City of Ketchum

Recommendation to Hold a Public Hearing and Approve the 108-110 Ritchie Lot Line Shift Final Plat & Findings of Fact, Conclusions of Law, and Decision.

IN RE:)	
)	
108-110 Ritchie Lot Line Shift)	KETCHUM CITY COUNCIL
Lot Line Shift)	FINDINGS OF FACT, CONCLUSIONS OF LAW, AND
Date: July 05, 2022)	DECISION
)	
File Number: P22-027)

PROJECT: 108-110 Ritchie Lot Line Shift

LOTS 3A, BLOCK 4, WARM SPRINGS VILLAGE 2ND ADDITION REVISED

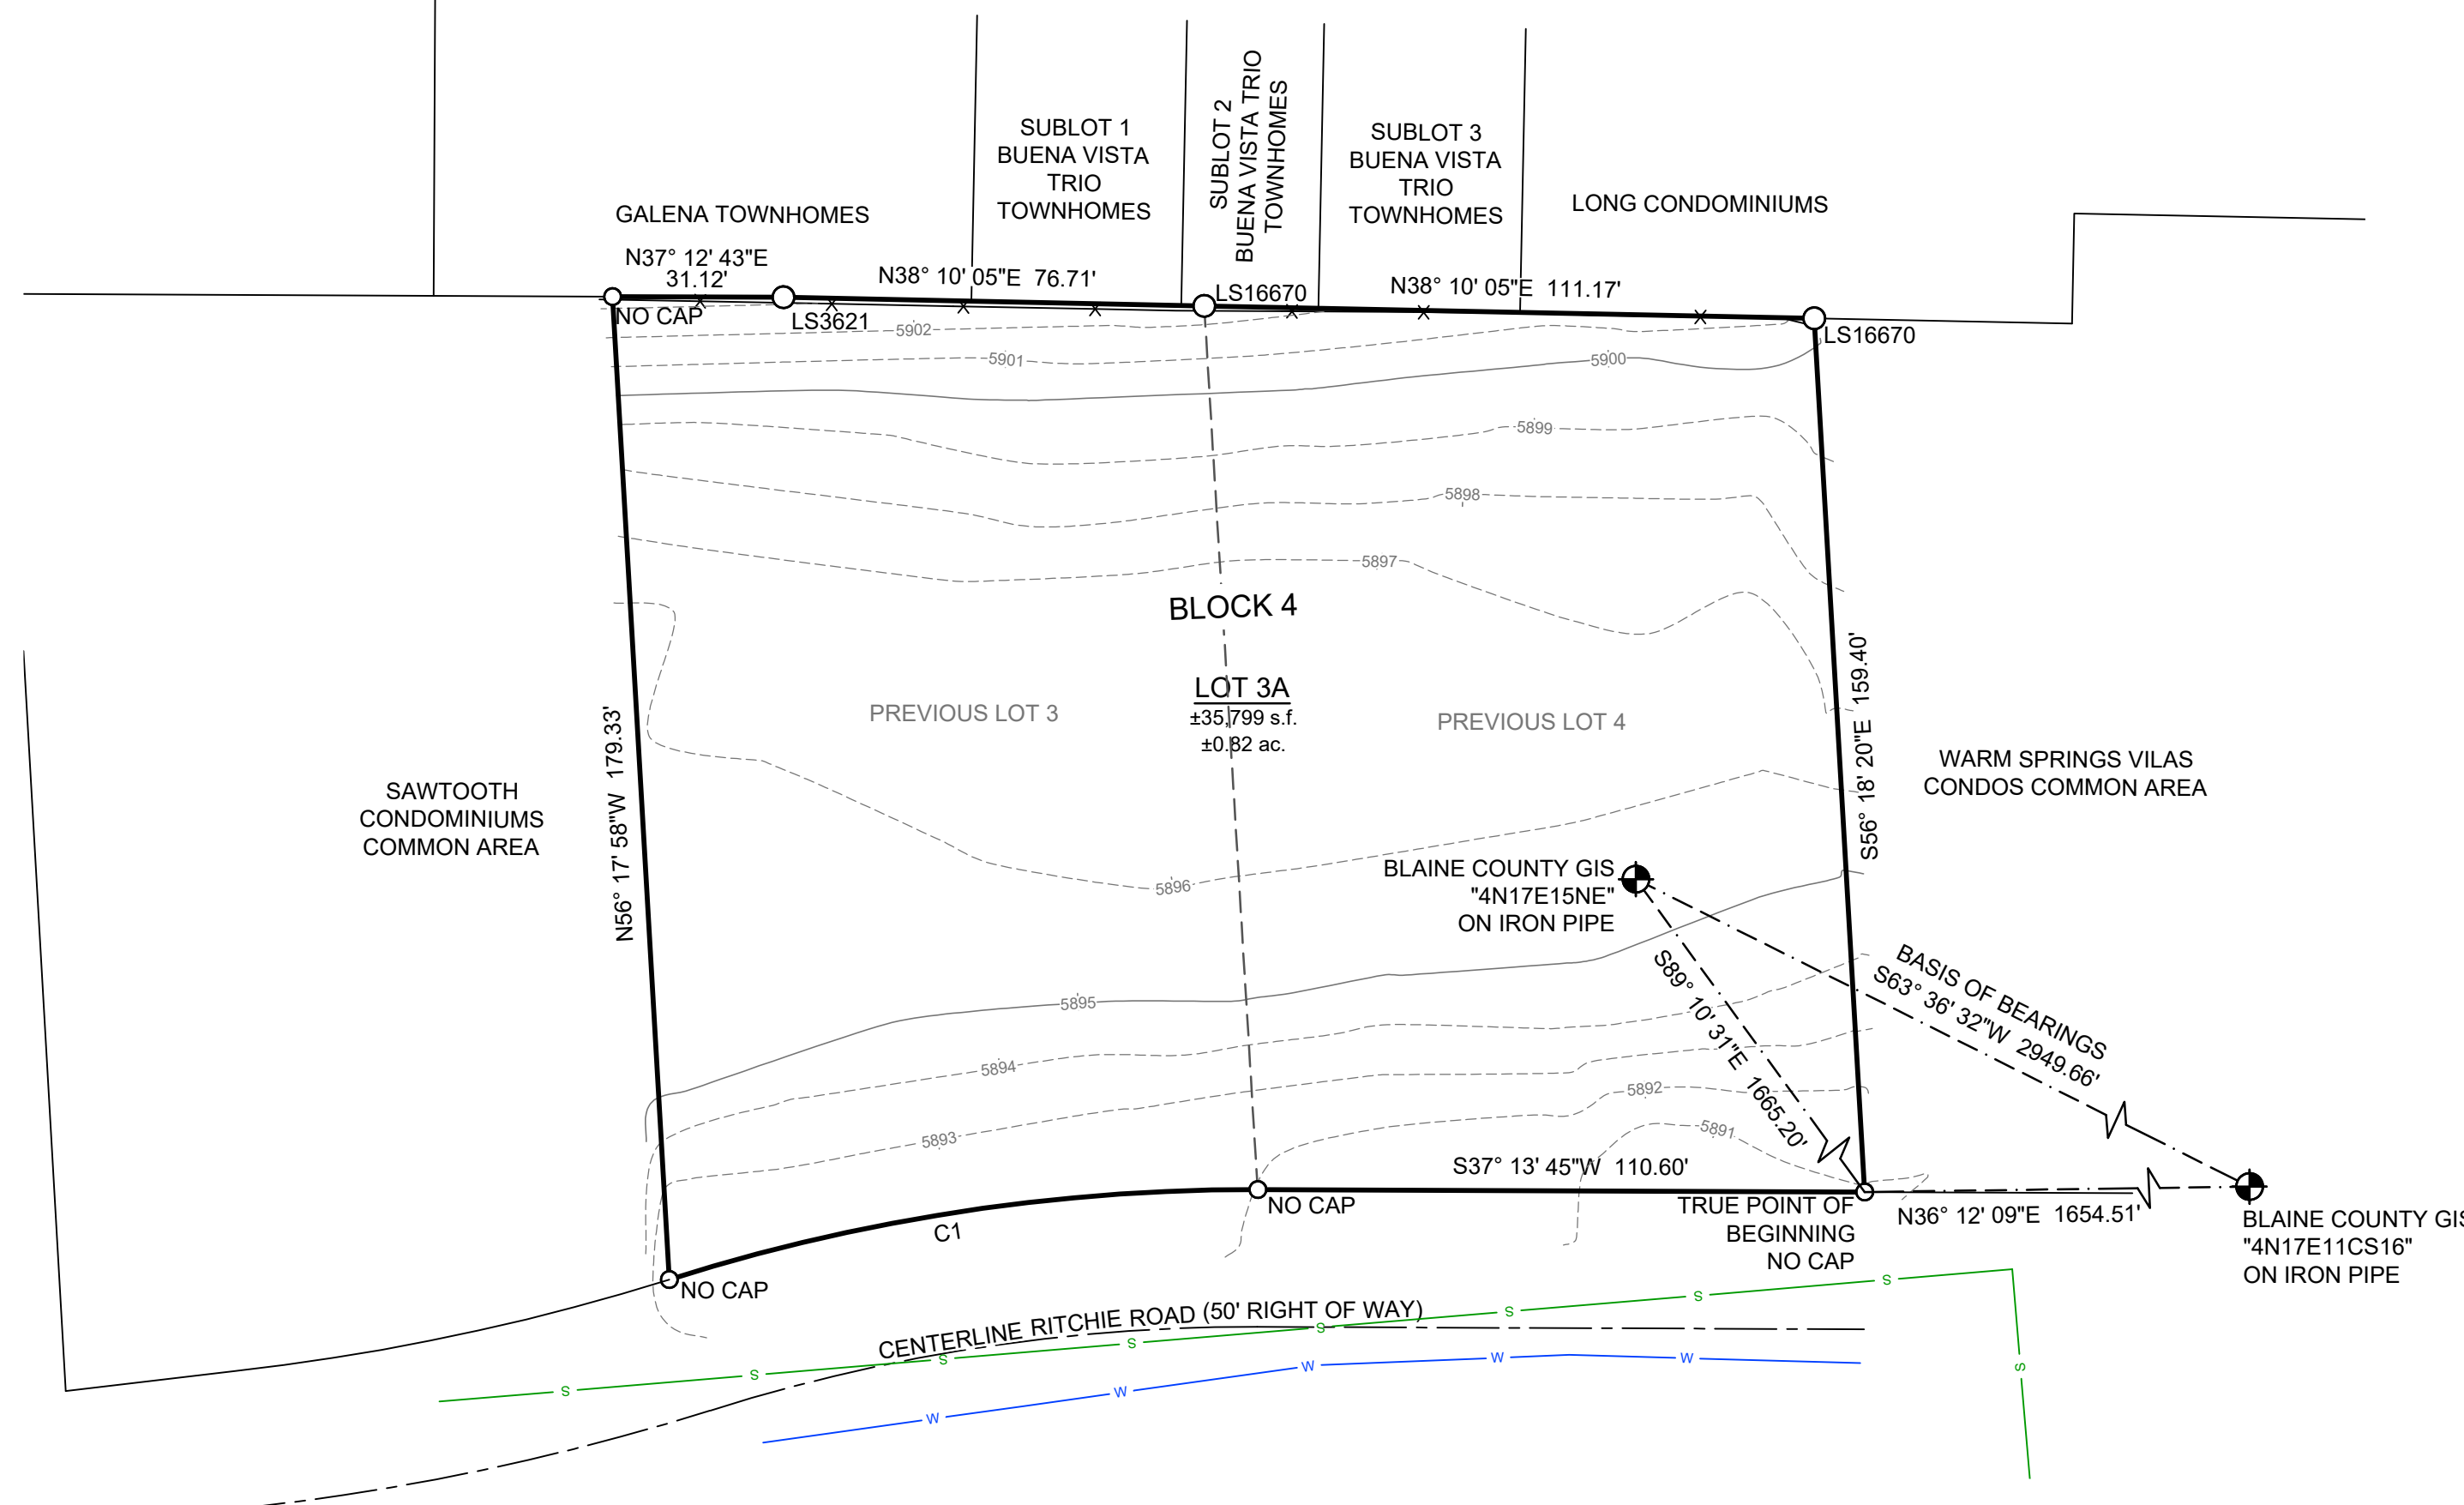
16.04.030.K.1 Point of beginning of subdivision description tied to at least two (2) governmental survey corners, or in lieu of government survey corners, to monuments recognized by the city engineer. Council Findings <i>As conditioned, this standard shall be met. The plat mylar shall show a minimum of two Blaine County Survey Control Monuments with ties to the property and an inverse between the two monuments. The Survey Control Monuments shall be clearly identified on the face of the map.</i>
<input checked="" type="checkbox"/>	<input type="checkbox"/>	<input type="checkbox"/>	16.04.030.K.2 Location and description of monuments. <i>As conditioned, this standard shall be met. The final plat mylar shall show the location and description of monuments.</i>

16.04.030.K.3 Tract boundary lines, property lines, lot lines, street right of way lines and centerlines, other rights of way and easement lines, building envelopes as required on the final plat, lot area of each lot, boundaries of floodplain and floodway and avalanche district, all with bearings, accurate dimensions in feet and decimals, in degrees and minutes and radii, arcs, central angles, tangents and chord lengths of all curves to the above accuracy. Council Findings <i>The plat indicates property lines and the centerline of Ritchie Dr.</i>
<input checked="" type="checkbox"/>	<input type="checkbox"/>	<input type="checkbox"/>	16.04.030.K.4 Names and locations of all adjoining subdivisions. Council Findings <i>The plat lists the adjacent condominium developments to the west, north and east.</i>

<input checked="" type="checkbox"/>	<input type="checkbox"/>	<input type="checkbox"/>	16.04.030.K.5	Name and right of way width of each street and other public rights of way.
			Council Findings	<i>This standard has been met. The plat indicates the Ritchie Dr public rights-of-way.</i>
<input type="checkbox"/>	<input type="checkbox"/>	<input checked="" type="checkbox"/>	16.04.030.K.6	Location, dimension and purpose of all easements, public or private.
			Council Findings	<i>No easements required on plat.</i>
<input checked="" type="checkbox"/>	<input type="checkbox"/>	<input type="checkbox"/>	16.04.030.K.7	The blocks numbered consecutively throughout each block.
			Council Findings	<i>This standard has been met.</i>
<input type="checkbox"/>	<input type="checkbox"/>	<input checked="" type="checkbox"/>	16.04.030.K.8	The outline of any property, other than a street, alley or easement, which is offered for dedication to public use, fully dimensioned by distances and bearings with the area marked "Dedicated to the City of Ketchum for Public Use", together with any other descriptive language with regard to the precise nature of the use of the land so dedicated.

Council Findings	<i>N/A as no new dedication is being proposed.</i>
<input checked="" type="checkbox"/>	<input type="checkbox"/>	<input type="checkbox"/>	16.04.030.K.9	The title, which shall include the name of the subdivision, the name of the city, if appropriate, county and state, and the location and description of the subdivision referenced to section, township, range.
			Council Findings	<i>This standard has been met.</i>
<input checked="" type="checkbox"/>	<input type="checkbox"/>	<input type="checkbox"/>	16.04.030.K.10	Scale, north arrow and date.
				<i>This standard has been met.</i>
<input checked="" type="checkbox"/>	<input type="checkbox"/>	<input type="checkbox"/>	16.04.030.K.11	Location, width, and names of all existing or dedicated streets and other public ways within or adjacent to the proposed subdivision
			Council Findings	<i>This standard has been met. Ritchie Dr is indicated on the subdivision plat.</i>

Council Findings	<i>As conditioned, this standard will be met prior to recordation of the Final Plat. The signature block page shall include the certification and signature of the surveyor verifying that the subdivision and design standards meet all City requirements.</i>
<input checked="" type="checkbox"/>	<input type="checkbox"/>	<input type="checkbox"/>	16.04.030.K.17	Certification and signature of the city engineer verifying that the subdivision and design standards meet all city requirements.
			Council Findings	<i>As conditioned, this standard will be met prior to recordation of the Final Plat. The signature block page shall include the City Engineer's approval and verification that the subdivision and design standards meet all City requirements.</i>

1. The amended plat mylar shall meet all conditions specified in Table 1: Findings Regarding Contents of Final Plat and Subdivision Design & Development Requirements.
2. The amended plat shall meet all governing ordinances, requirements, and regulations of the Fire Department (2012 International Fire Code and local Fire Protection Ordinance No. 1125), Building Department (2012 International Building Code, the 2012 International Residential Code, and Title 15 of Ketchum Municipal Code), Utilities Department, Street Department (Title 12 of Ketchum Municipal Code), and the City Engineer.
3. The recorded plat shall show a minimum of two Blaine County Survey Control Monuments with ties to the property and an inverse between the two monuments. The Survey Control Monuments shall be clearly identified on the face of the map.
